REVISION LOG	
REVISION:001	DATE: 2-9-24

Redlines completed 7-Mar (DP)
-Missing Sealed Eng Plans

Lot 10 Duncan's Creek

The Guilford French Country - RH

OPTIONAL POCKET OFFICE, MESSY KITCHEN & POWER PANTRY
 SCALE: 1/4" = 1'-0" ON 22x34, 1/8" = 1'-0" ON 11x17

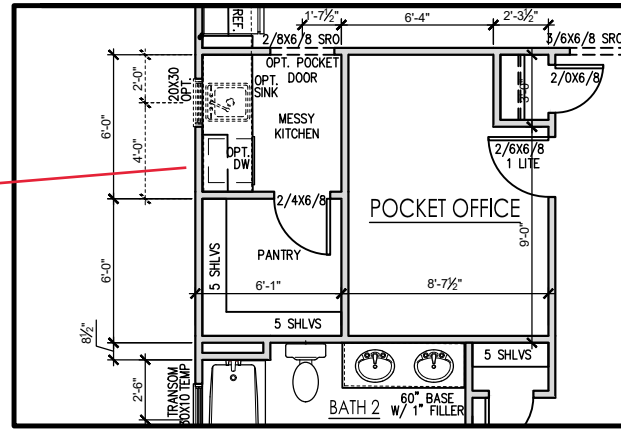
Add window and sink ←

SECOND FLOOR - FRENCH COUNTRY B
SCALE: 1/4" = 1'-0" ON 22x34, 1/8" = 1'-0" ON 11x17

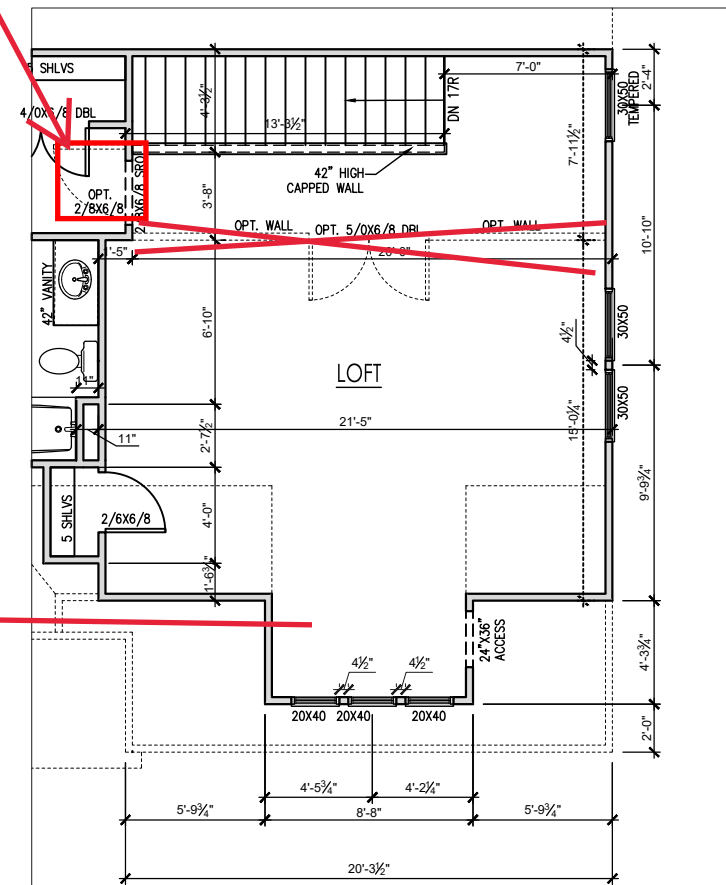
Add hallway door
